Waterford Place
Site Plan Amendment No.1

WATERFORD PLACE SUBDIVISION FILING NO. 2 AND WATERFORD PLACE SUBDIVISION FILING NO. 2, AMENDMENT NO. 1
SITUATED IN THE NW 1/4 OF SECTION 26, T.4S., R.67W. OF THE 6TH P.M.
CITY OF AURORA, COUNTY OF ARAPAHOE, STATE OF COLORADO

Cover Sheet, SDP.1

Amendment to Waterford Place
Landscape Plan, SDP.3
Sheet 3 of 8
Prepared on 6-14-2024

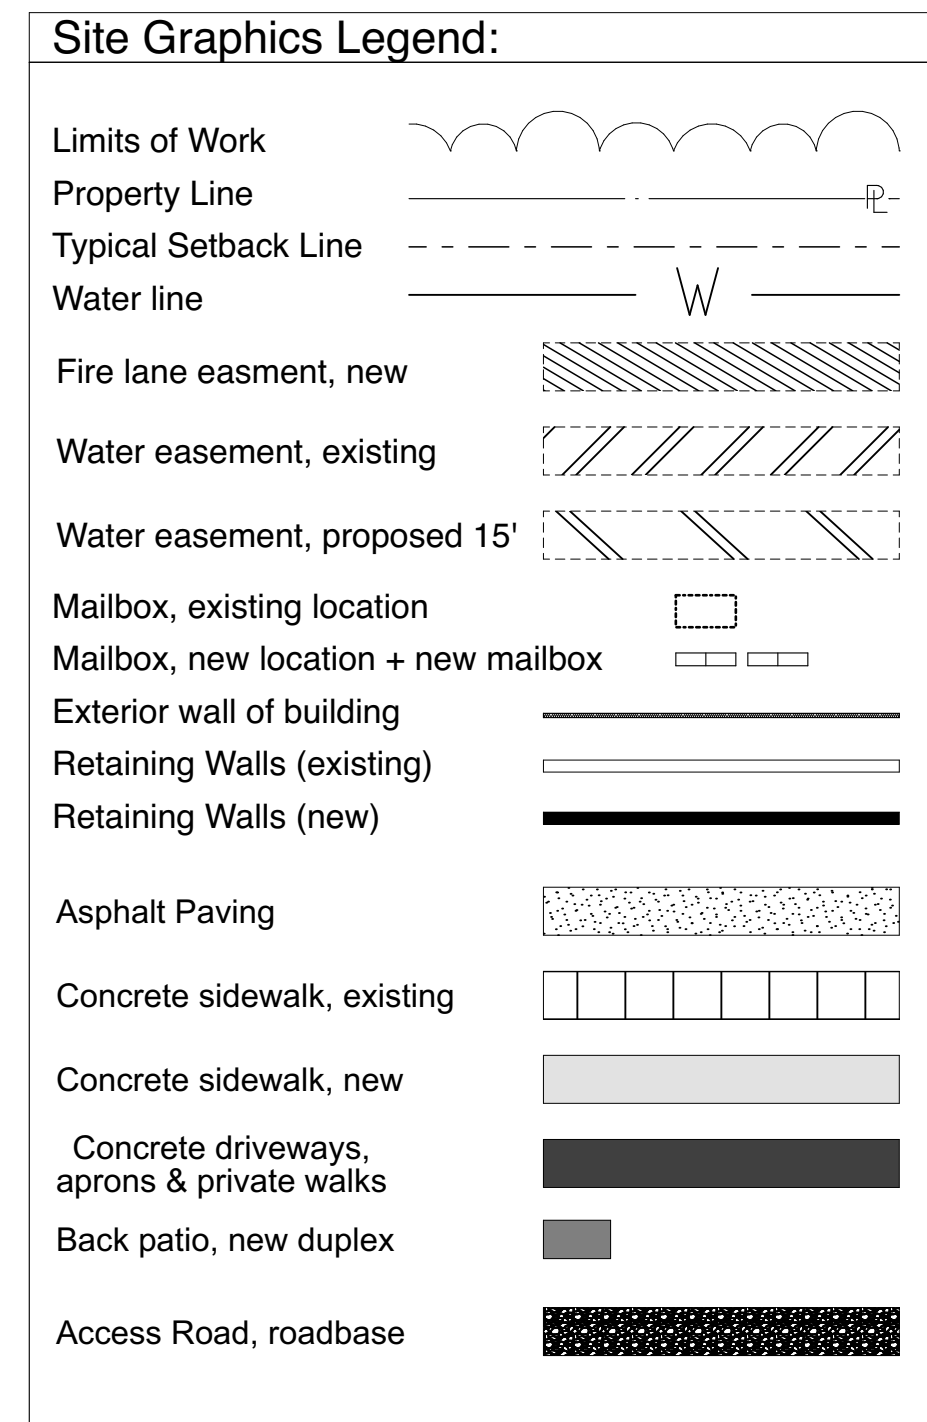
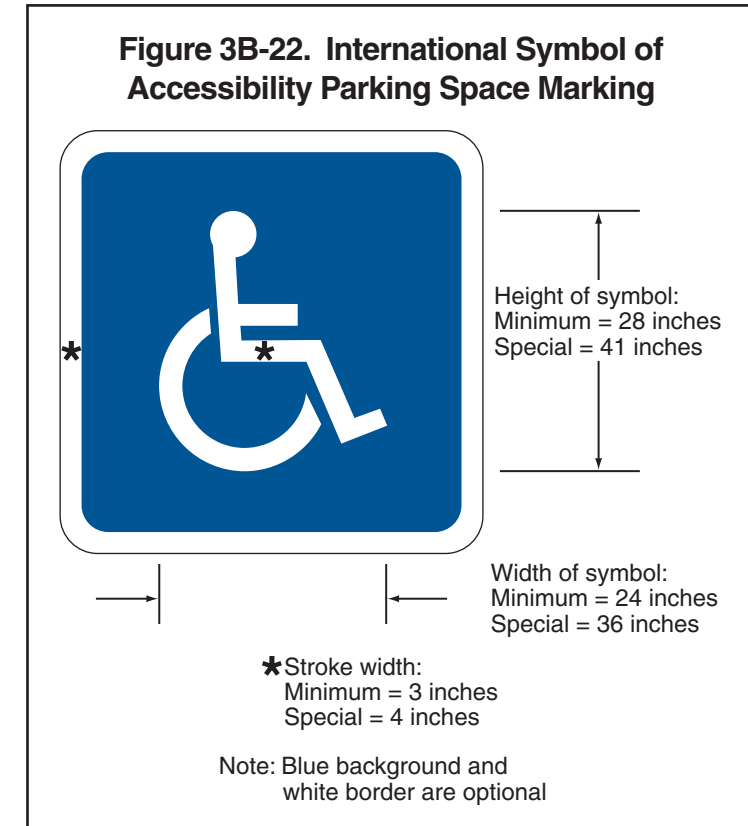
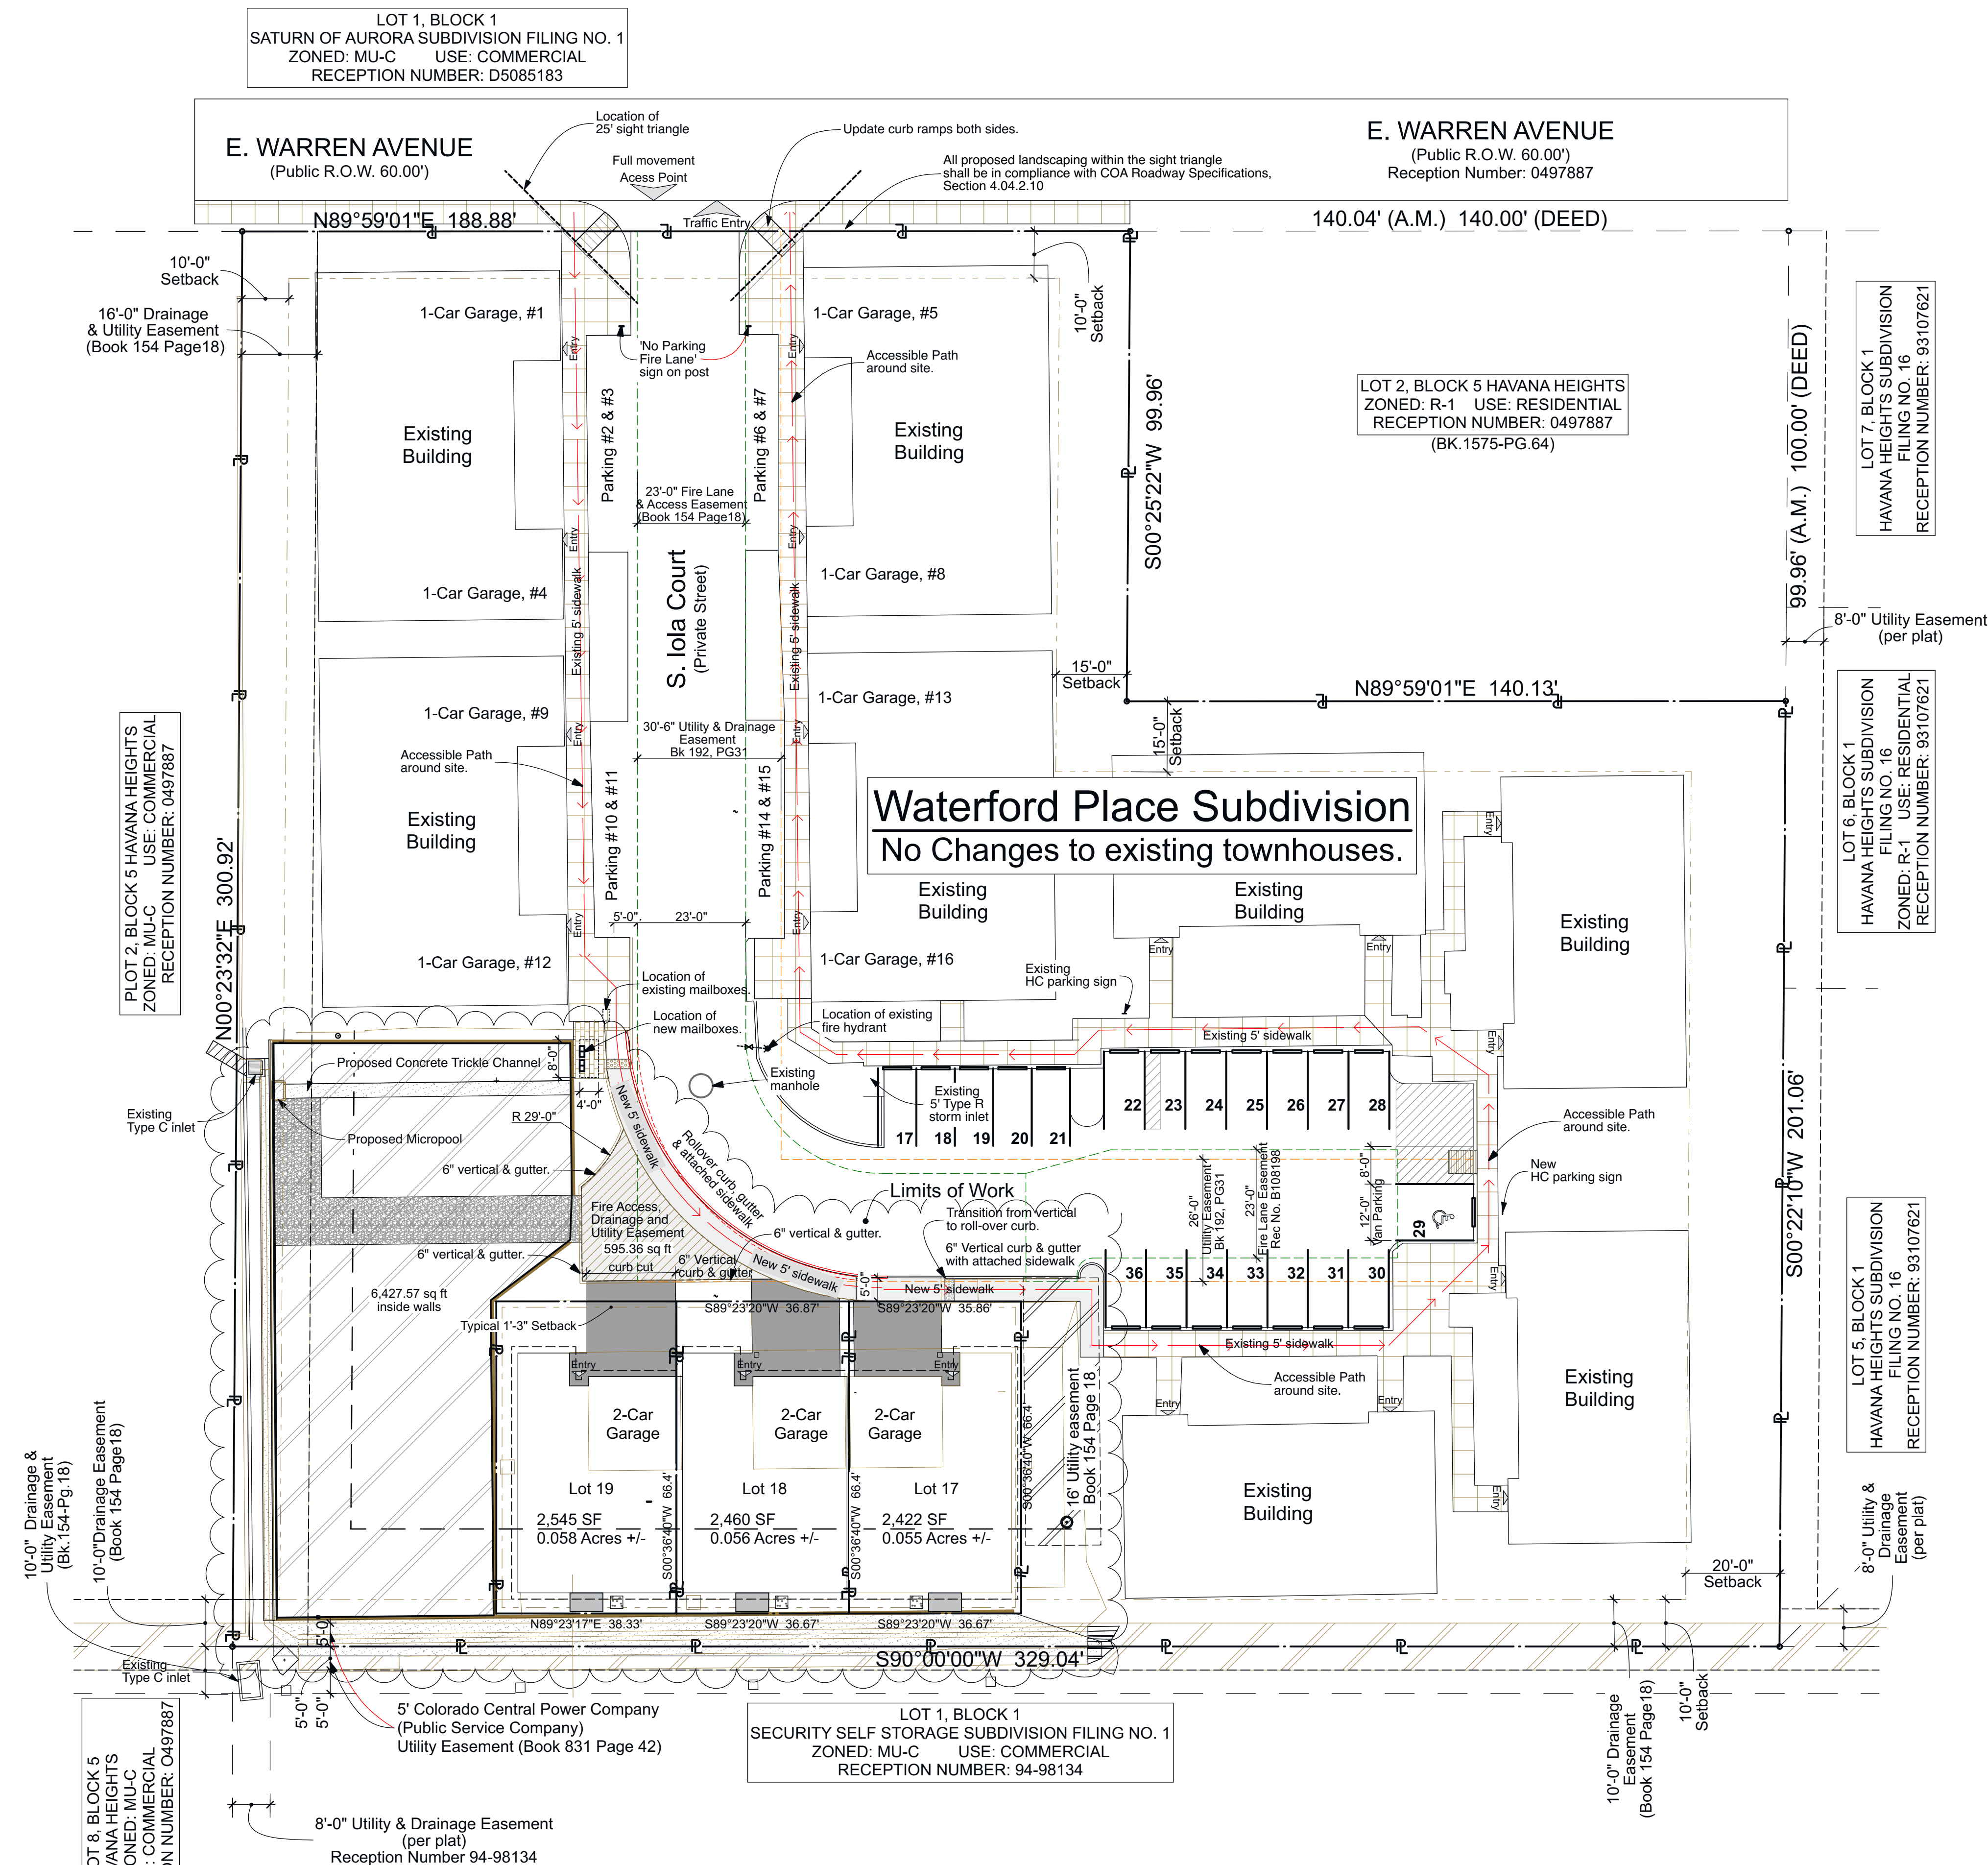
List who prepared the landscape plan.

Place the grading and utility plan sheets before the landscape plan.

Pages sheet number only.

Do not do X of X.
Just the actual sheet number 1, 2, 3 etc.

Pages re ordered.

Landscape plan by:
Earth and Sky Architecture
...

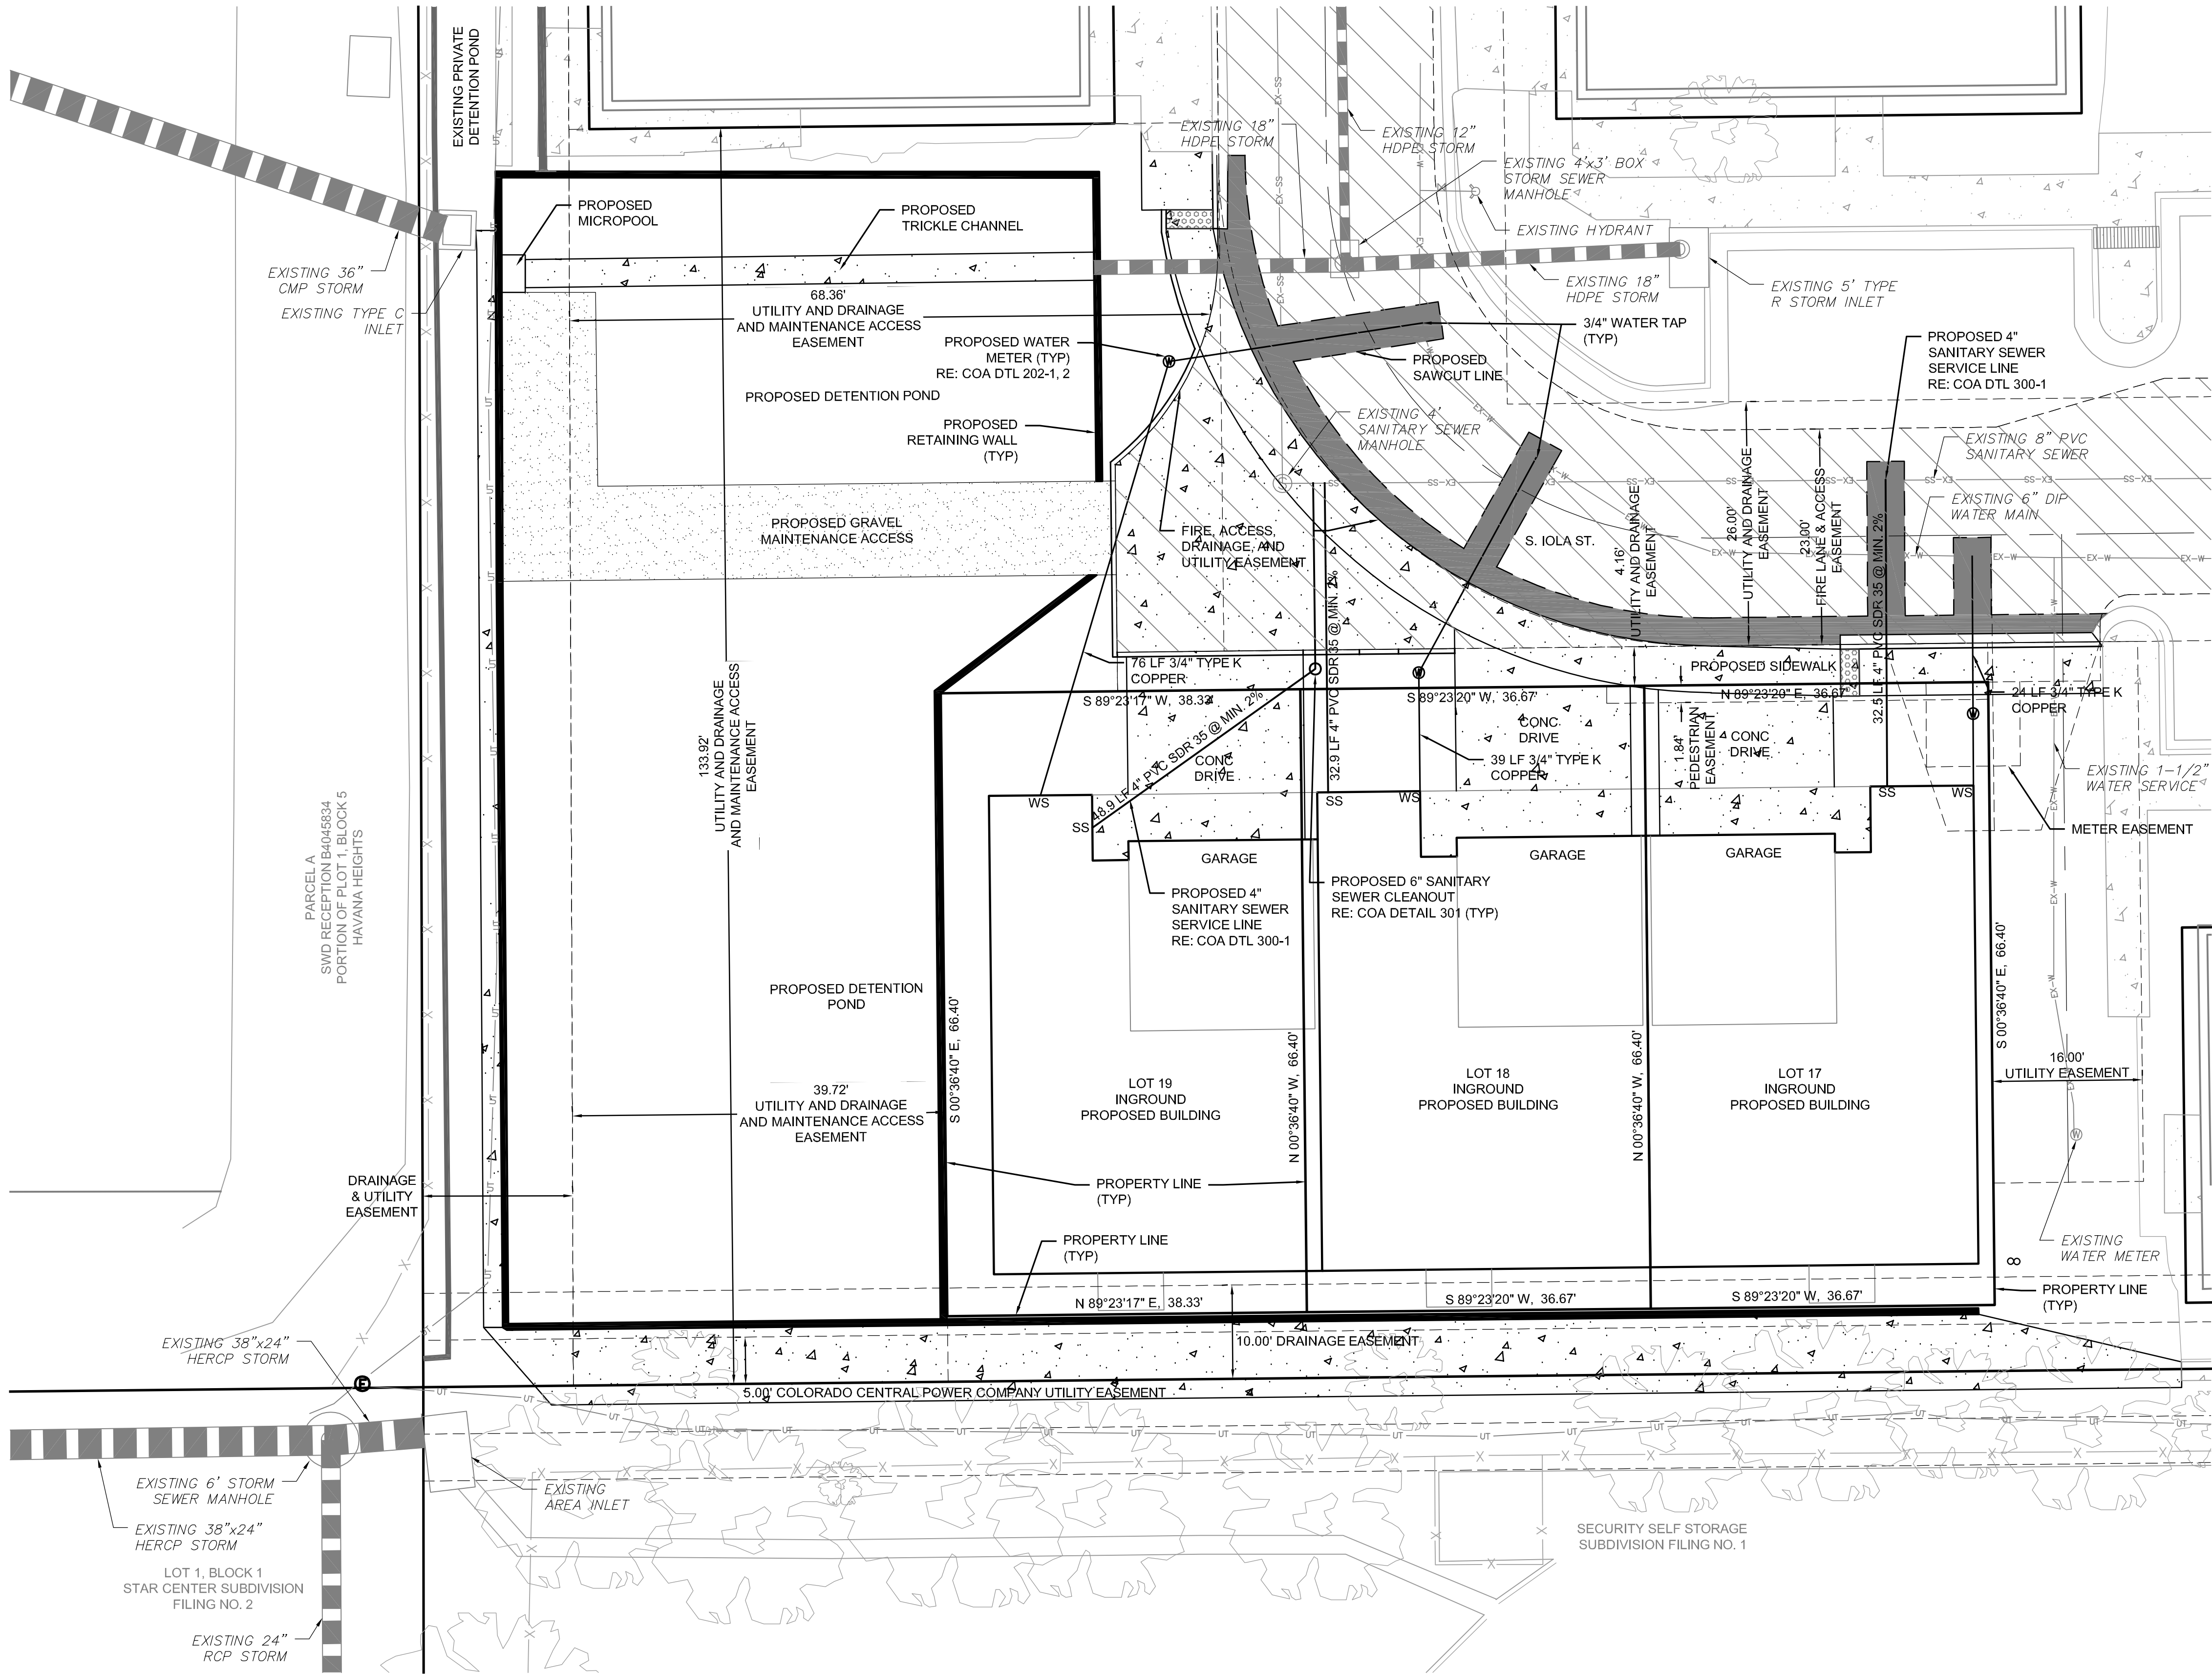
Unless the pond is an activated space for residents to use, like a park, then sod is not permitted in accordance with the Non-Functional Turf Ordinance. This should be a seed mix suitable to detention pond conditions.

There are no trees or shrubs being provided. While there are easements that preclude the installation of trees along the southern and western buffers, shrubs are permitted within easements.

Existing trees on an adjoining lot can not count towards the requirements for this site.

Not permitted by code. Must be shrubs, trees etc. to meet the buffer requirements.

Make sure the numbers align under the appropriate columns of the table.

Sod area changed to mulched bed for shrubs.

Text formatted to align with column
